GOVERNMENT OF MADRAS.
PUBLIC WORKS DEPARTMENT.

ORDER—dated 26th September 1895, No. 2381 W., Public Works.

The design applied for by the Superintending Engineer is now obsolete and a revised design recently prepared is circulated for adoption.

REVISED TYPE DESIGN FOR A DEPUTY TAHSILDARS OFFICE-TILED ROOFING.

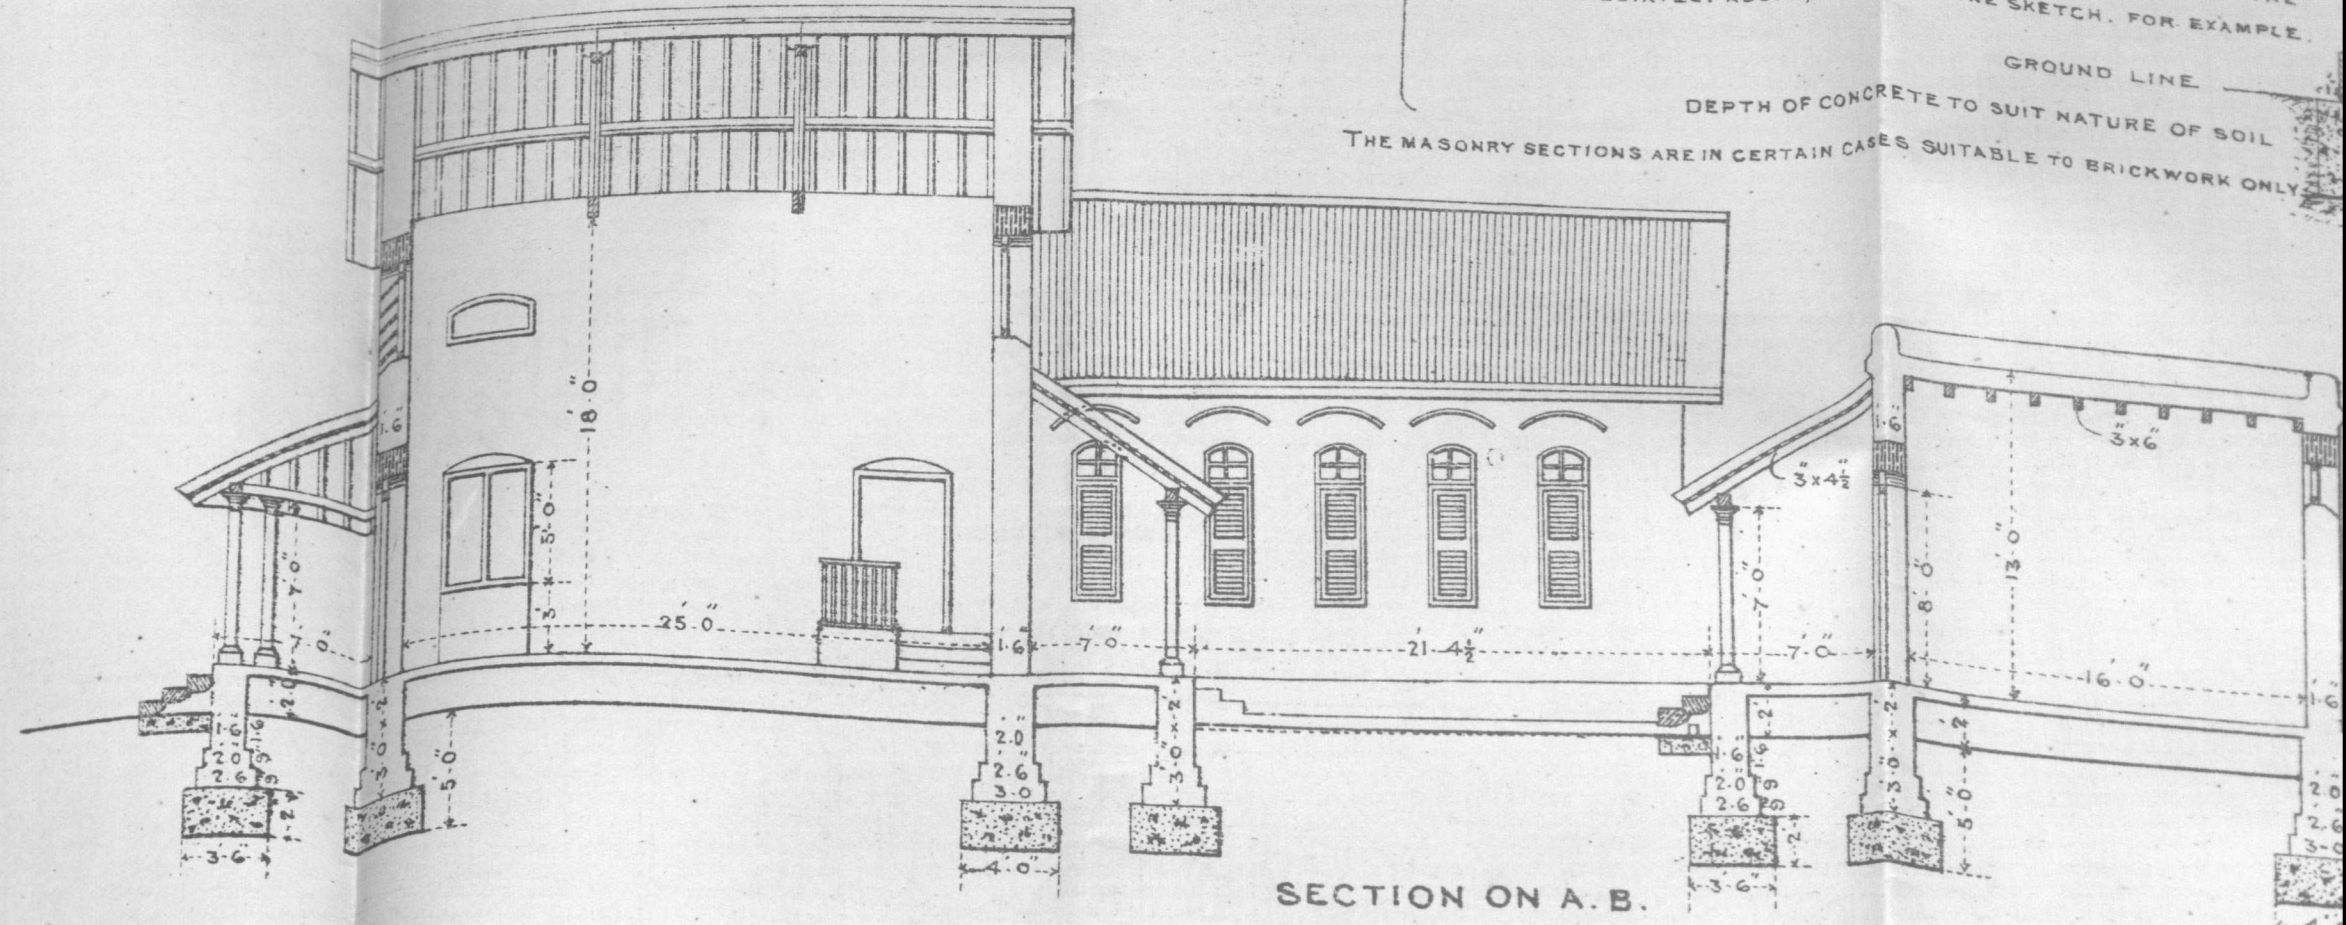
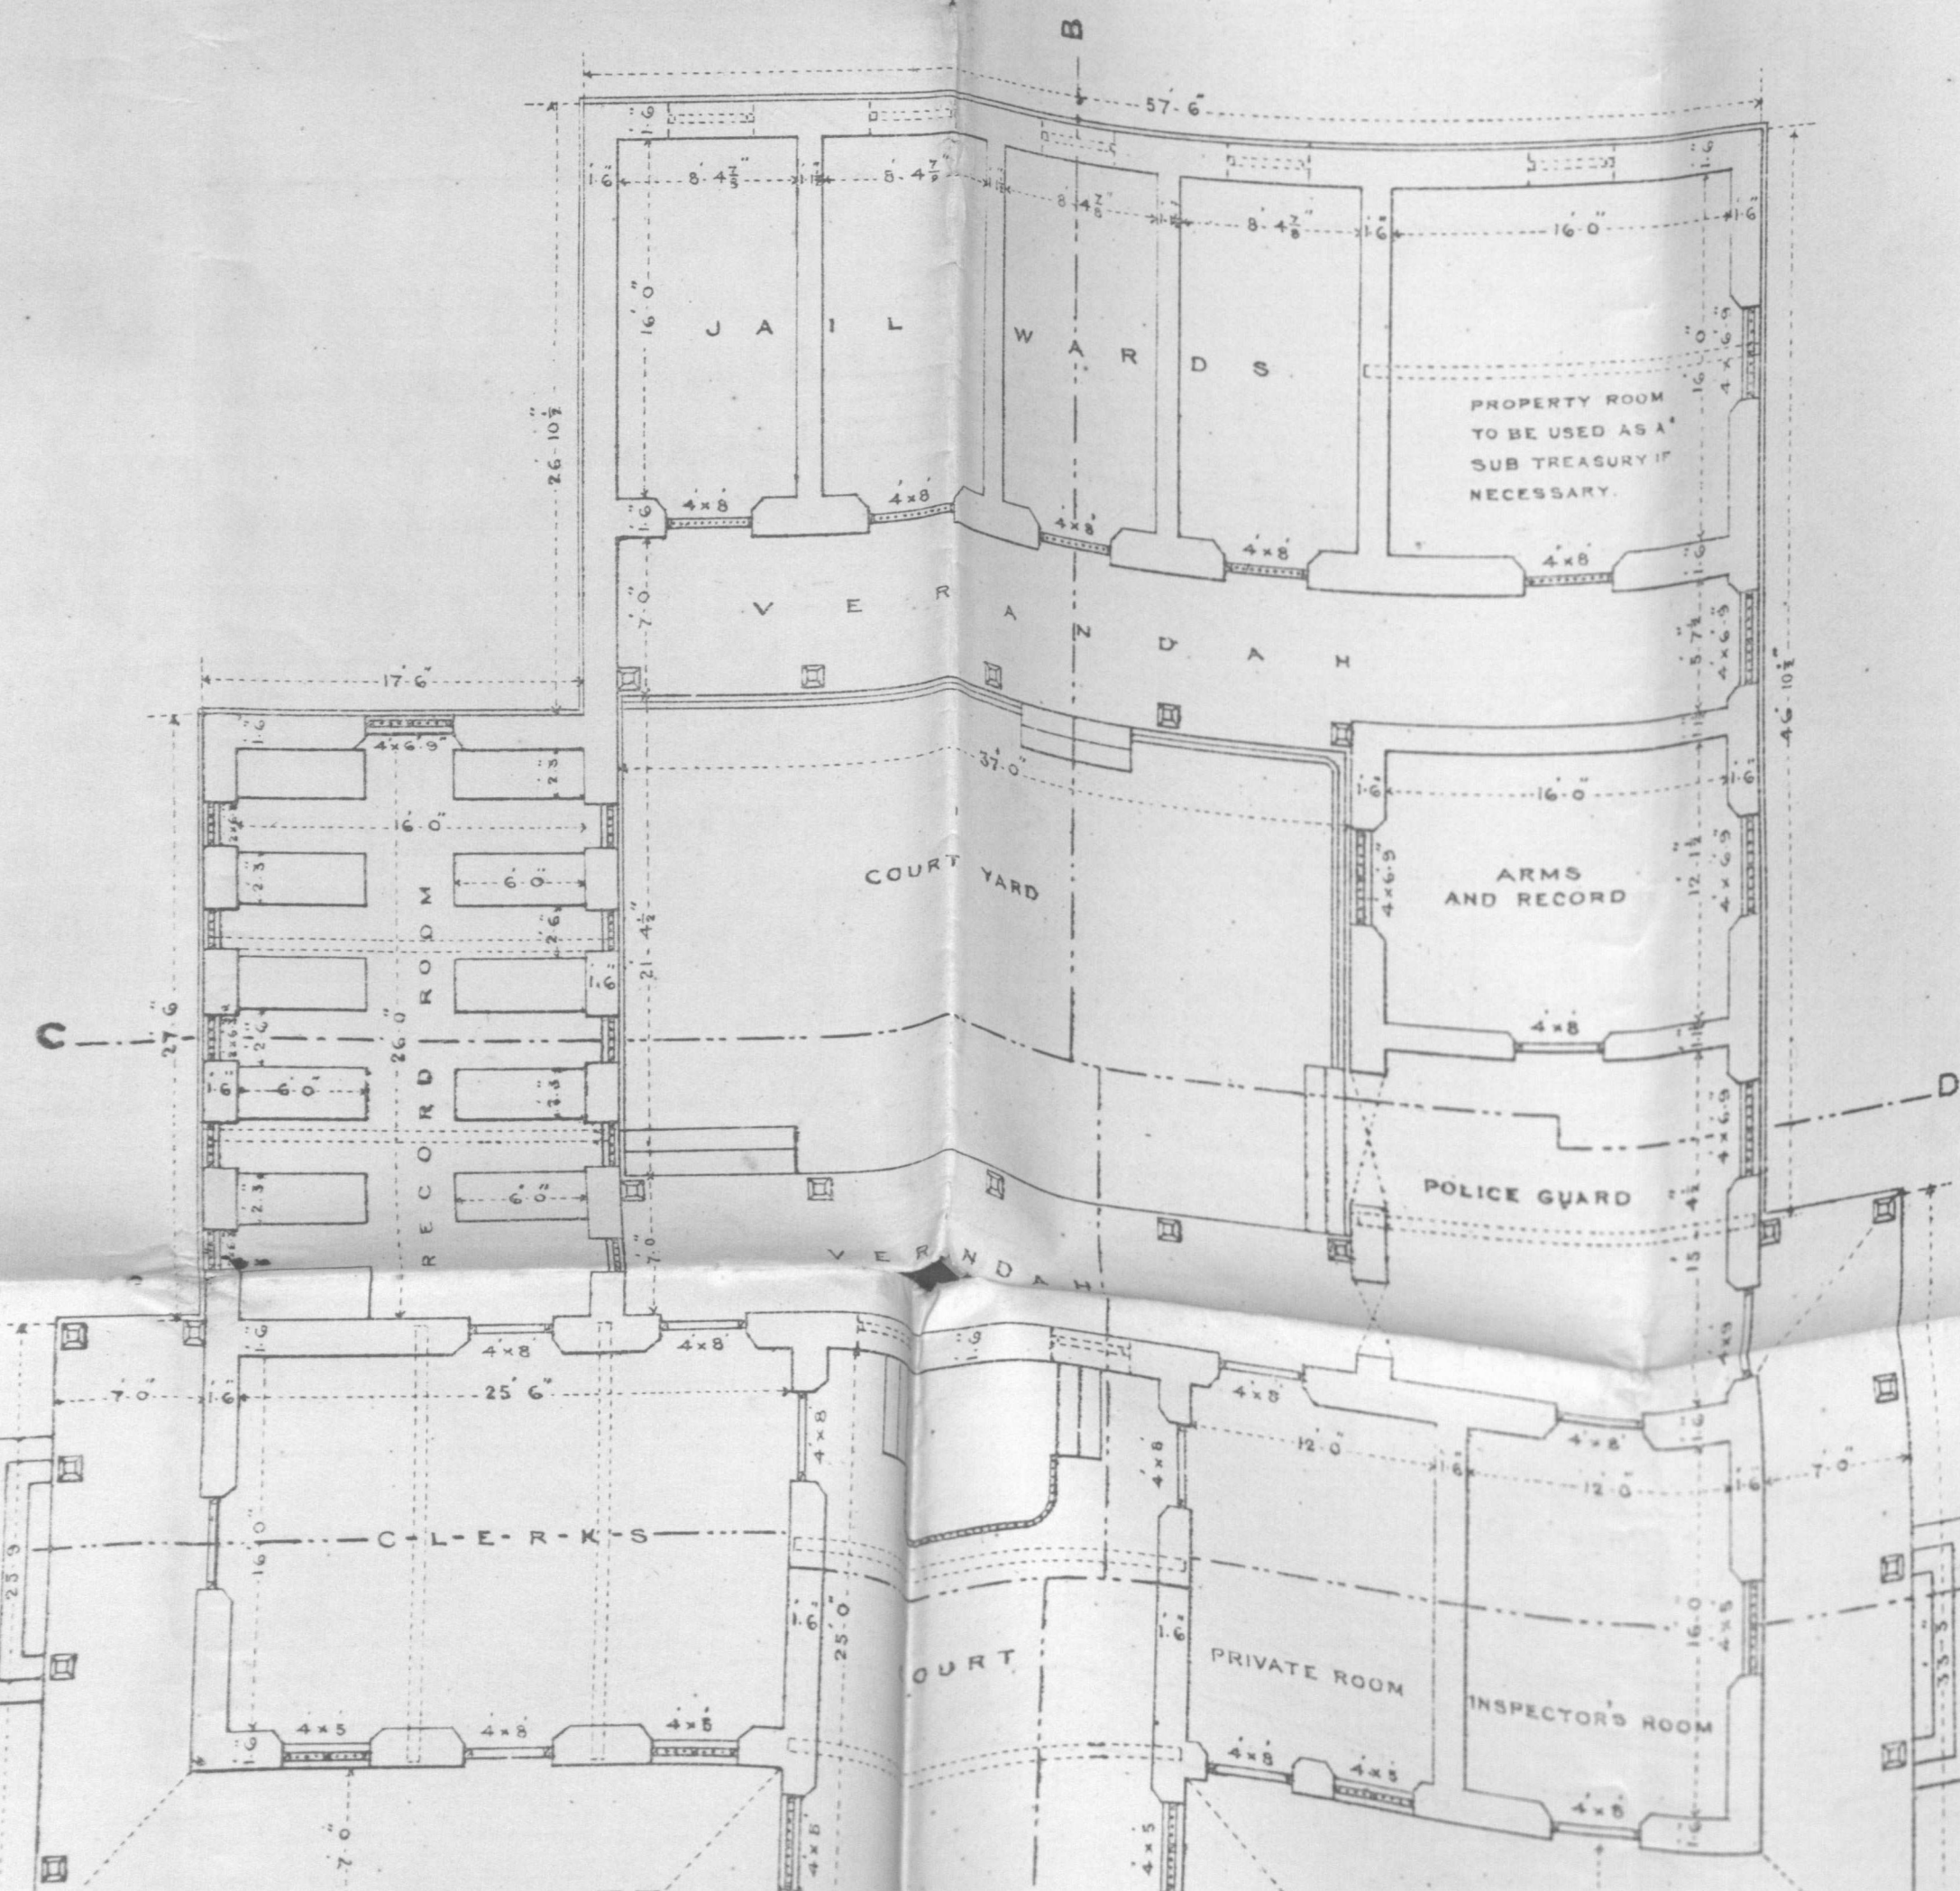
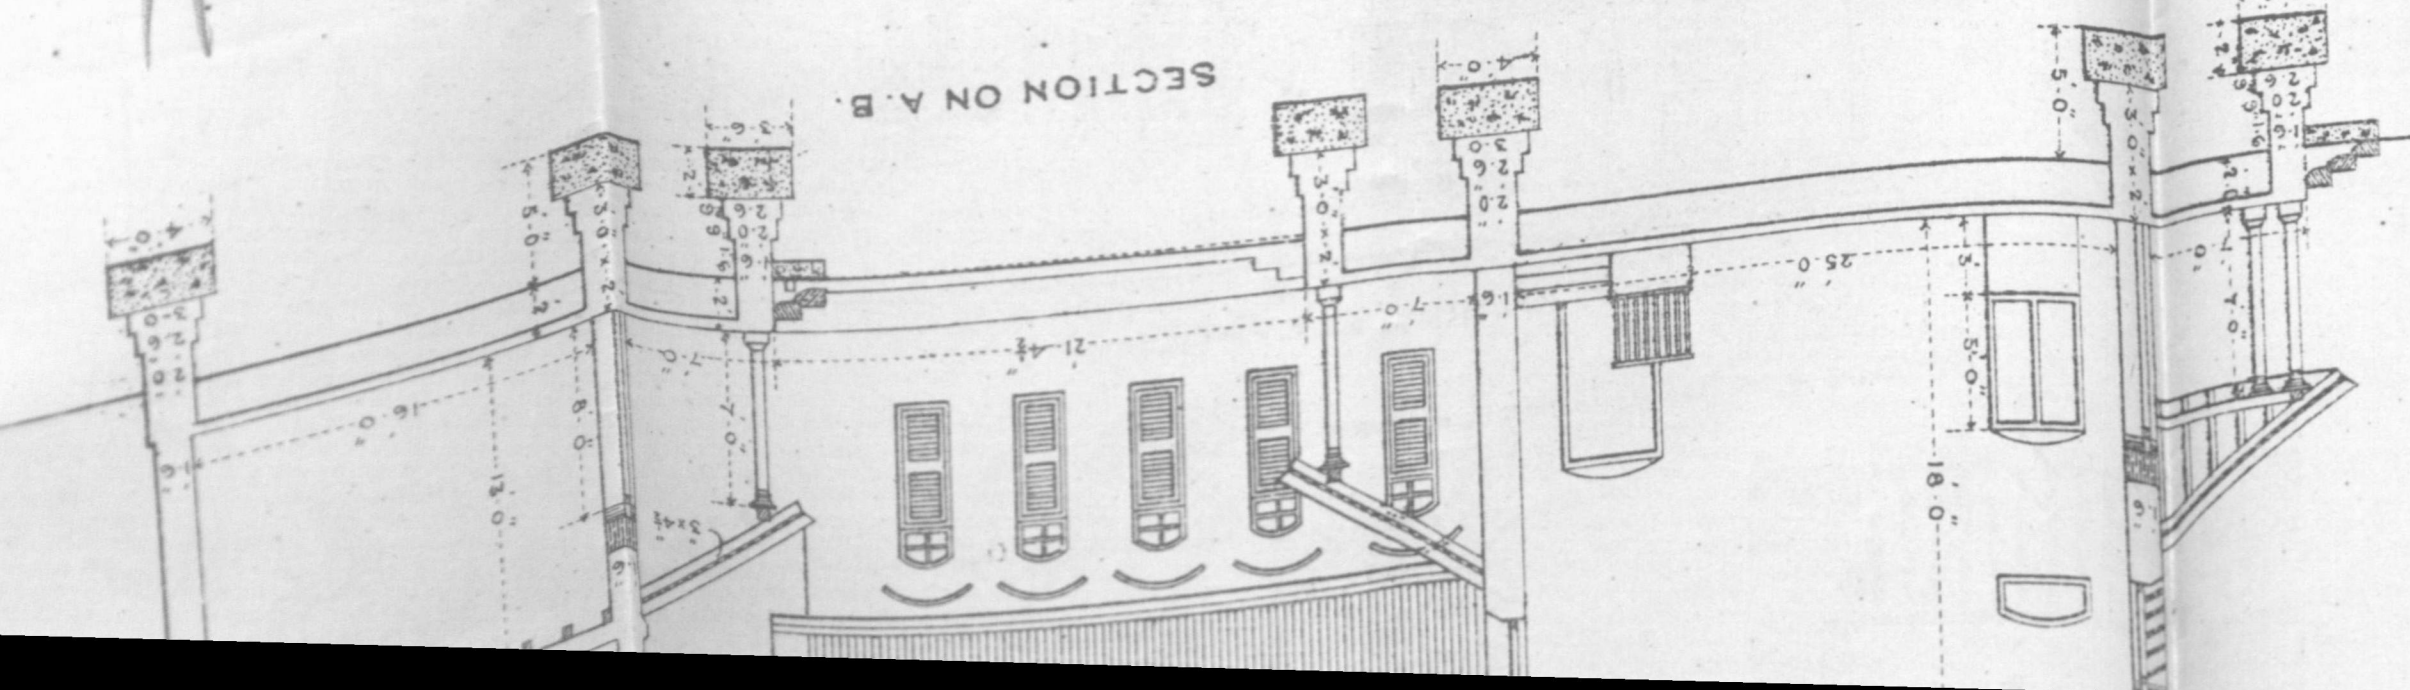
The revised design pro-
vides for the elongation
of the side verandah to the
police guard & altering
the position of steps at
sides, also it now shows
the elevation of the record room
the side elevation & the
position of fences on ground
plan.

NOTE. THE FOUNDATIONS AS SHOWN SHOULD NOT BE TAKEN AS A GUIDE. IT WOULD BETTER TO CONSTRUCT THEM OF CONCRETE TO GROUND LEVEL. THE CONCRETE TO BE 2 FEET, ONE FOOT ON EACH SIDE BROADER THAN THE MASONRY IMMEDIATELY ABOVE, AS SHOWN IN THE SKETCH. FOR EXAMPLE.
